Planning Commission Regular Meeting | 5:30 PM

Wednesday, October 29, 2025

Final Plan Review for New Home

Hearing Date:	October 29, 2025
File Name and Process:	Single-Family Residence Final Plan Review
Owner/Applicant:	Clay & Becky Stevens
Representative:	Taylor Hermes & Rick Hermes, Minturn North Construction Company
Legal Description:	Subdivision: MINTURN NORTH PUD Lot: 1
Address:	0246 Miles End Lane
Zoning:	Game Creek Character Area – Minturn North PUD Zone District
Staff Member:	Madison Harris, Planner I
Recommendation:	Approval

Boundaries Unlimited Inc. Civil Engineering Surveying & Beyond

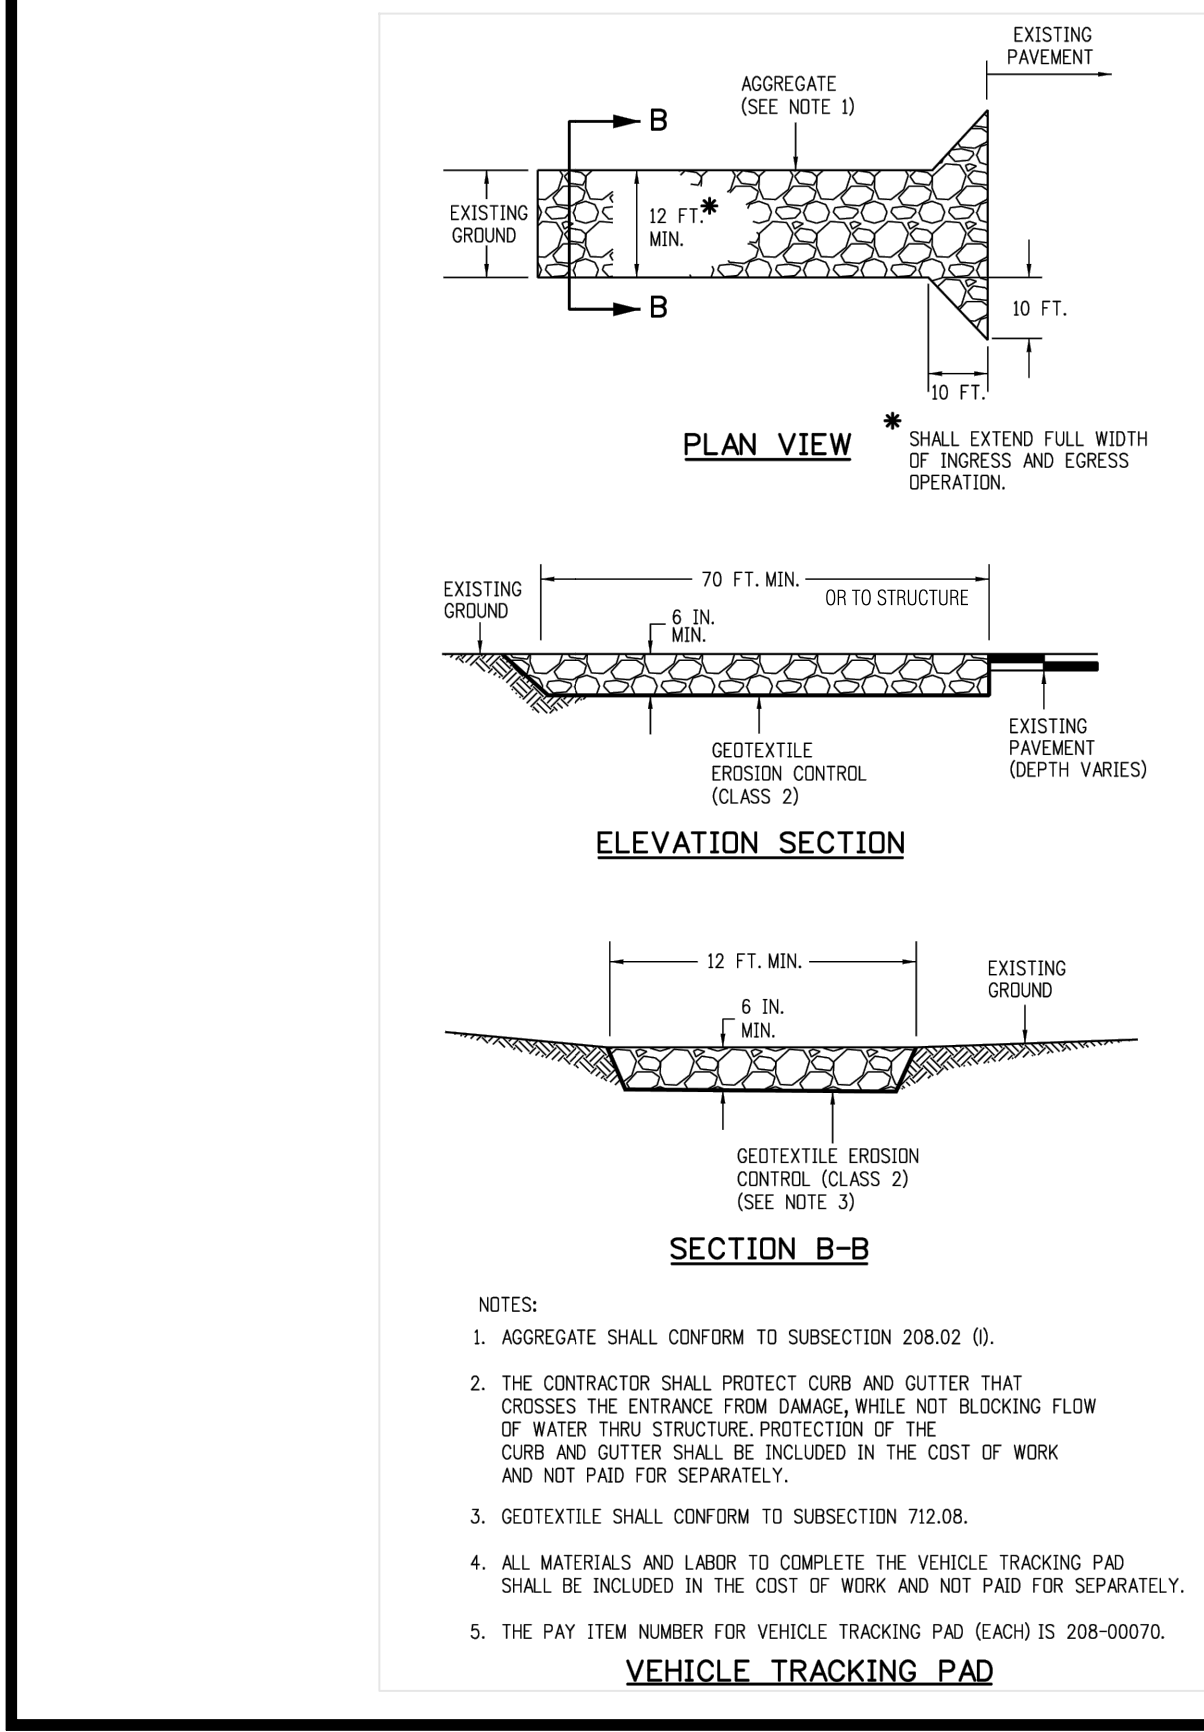
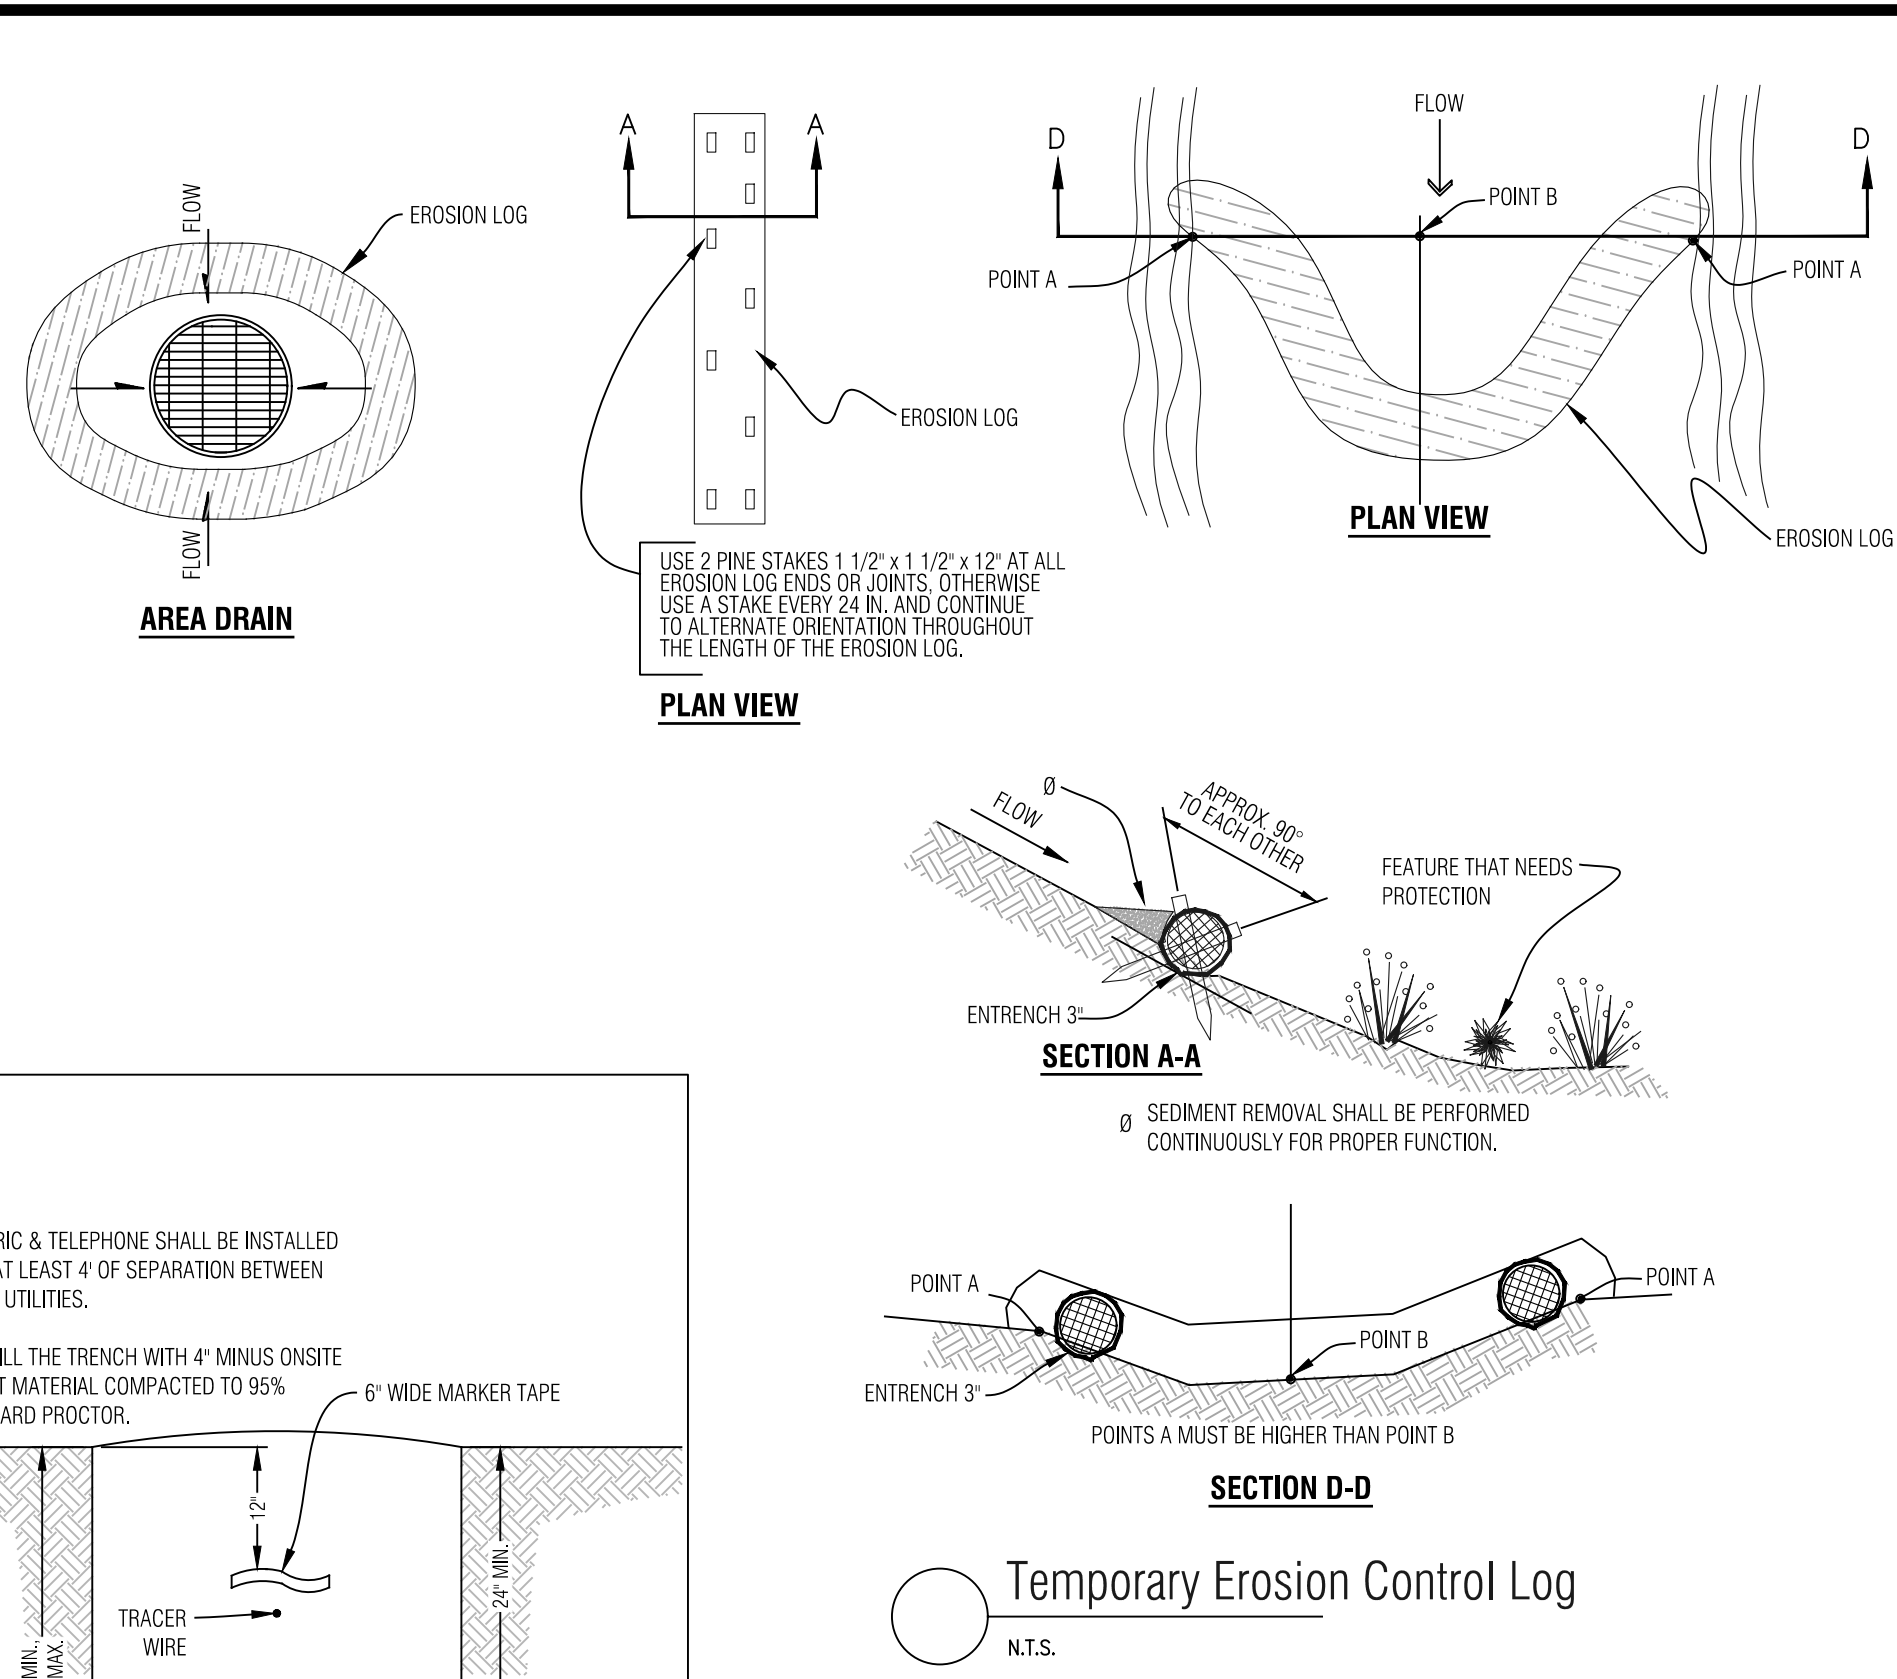
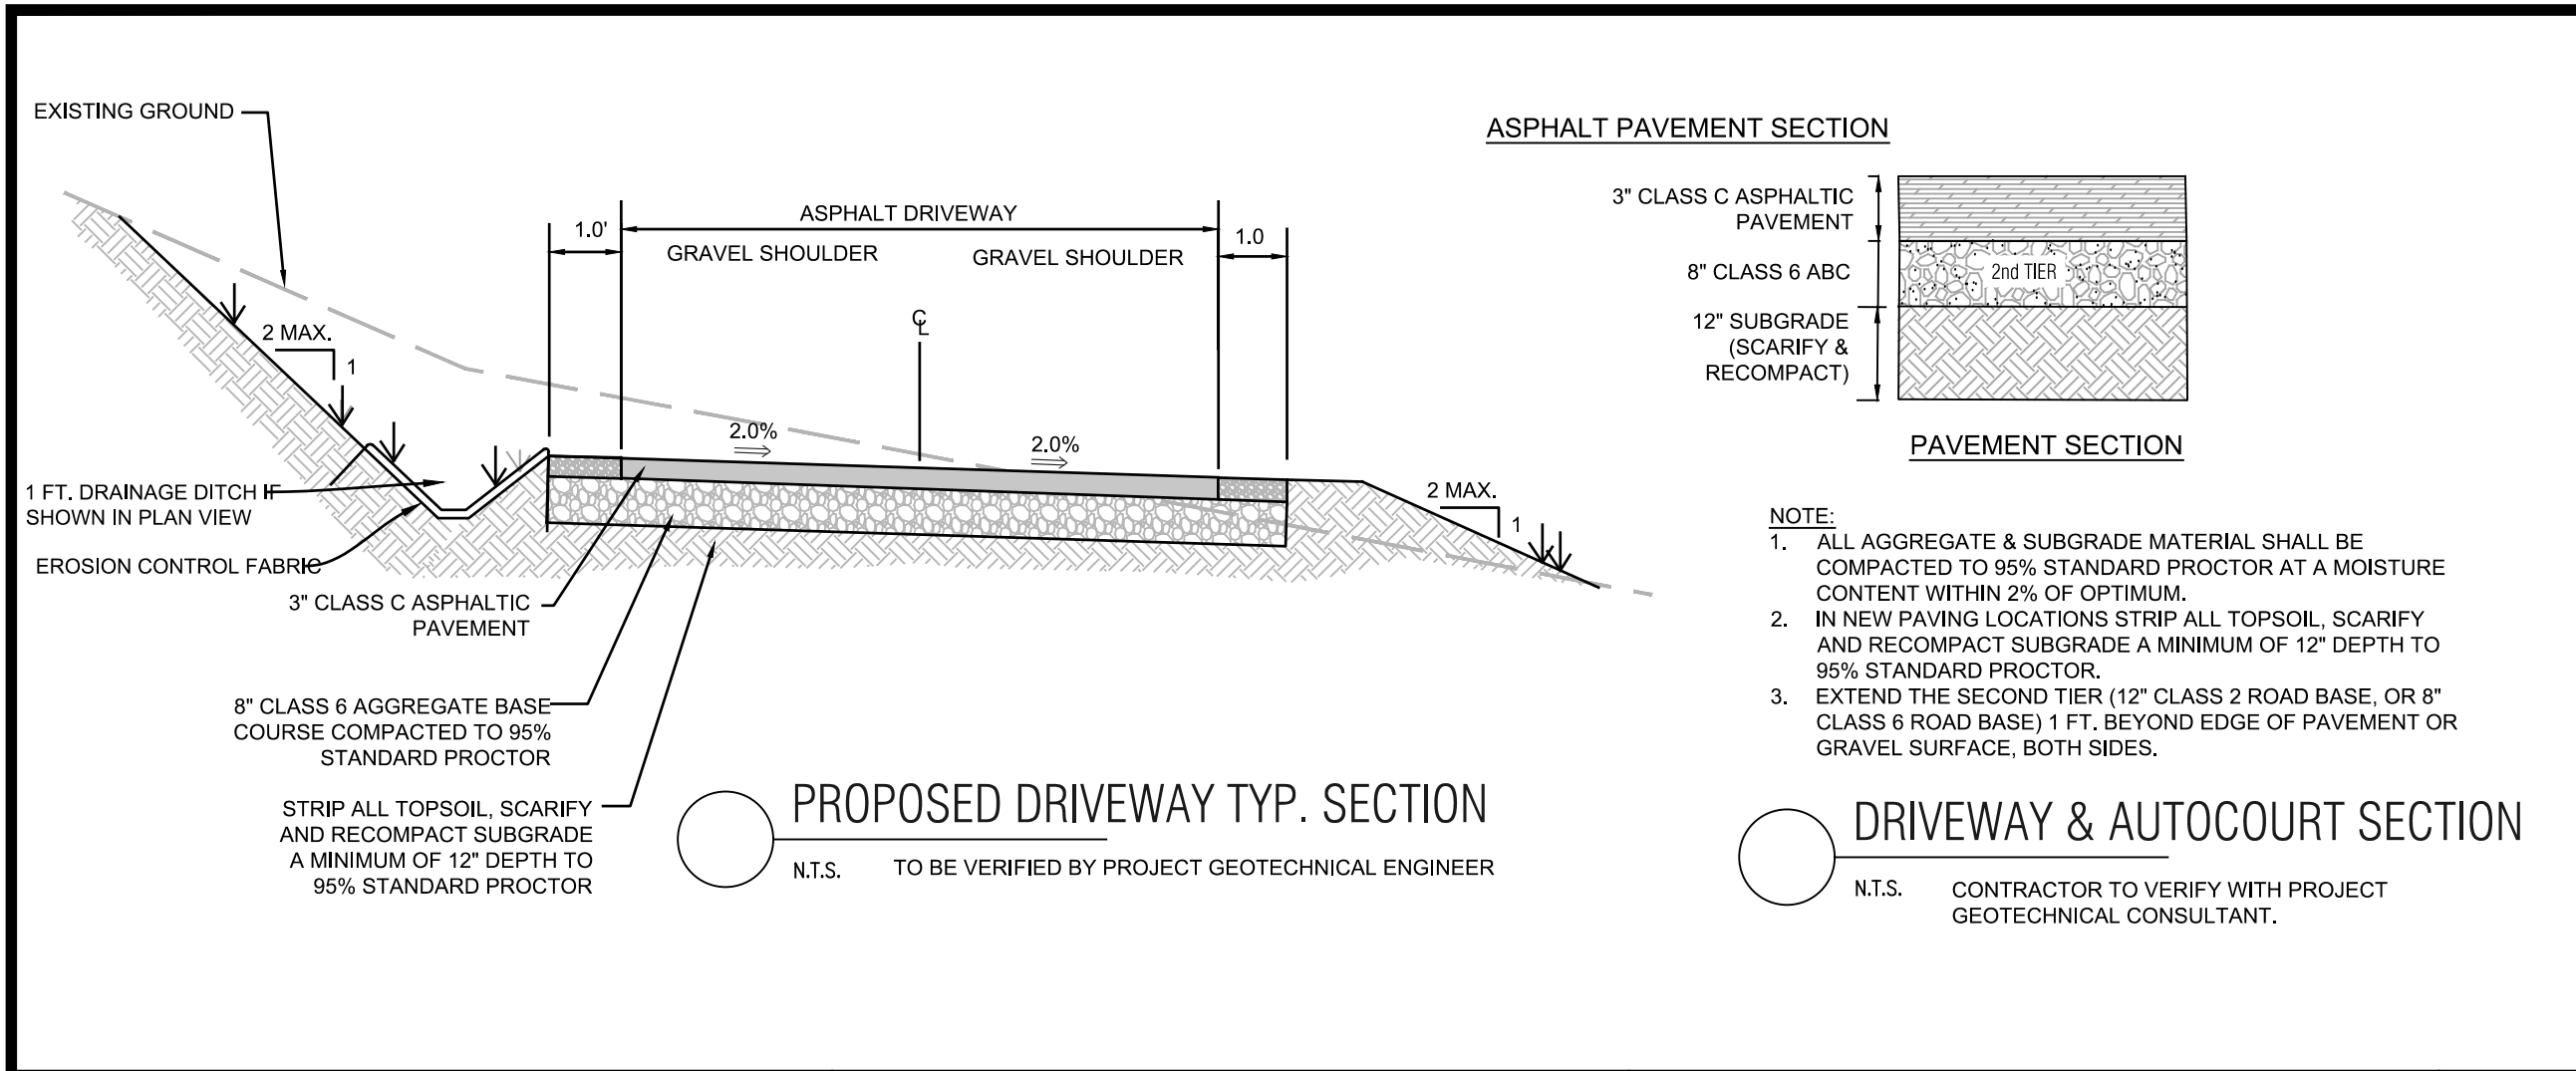
2. Sheet C1 of the Plans *“Lot 1 Minturn North PUD; Site Grading and Drainage Plan”* dated September 18, 2025, by Boundaries Unlimited presents the proposed Site Plan.
 - i. The site plan shows the 30’ Setback to the “Ordinary High Water Mark” (OHWM) of Game Creek. Improvements are located outside of the OHWM setback as shown.
 - ii. The site plan identifies the location of the 100 Year Flood Plain and the “Proposed 100 Year Mudflow extents.” Improvements are located outside of the identified limits of the hazard zones.
 - iii. The water curb stop is located in the driveway and should be protected from snowplowing damage by enclosing it in a water valve box.

Sheet C1 of the Plans *“Lot 1 Minturn North PUD; Site Grading and Drainage Plan”* dated September 18, 2025, by Boundaries Unlimited presents the proposed site grading, drainage, and erosion control.
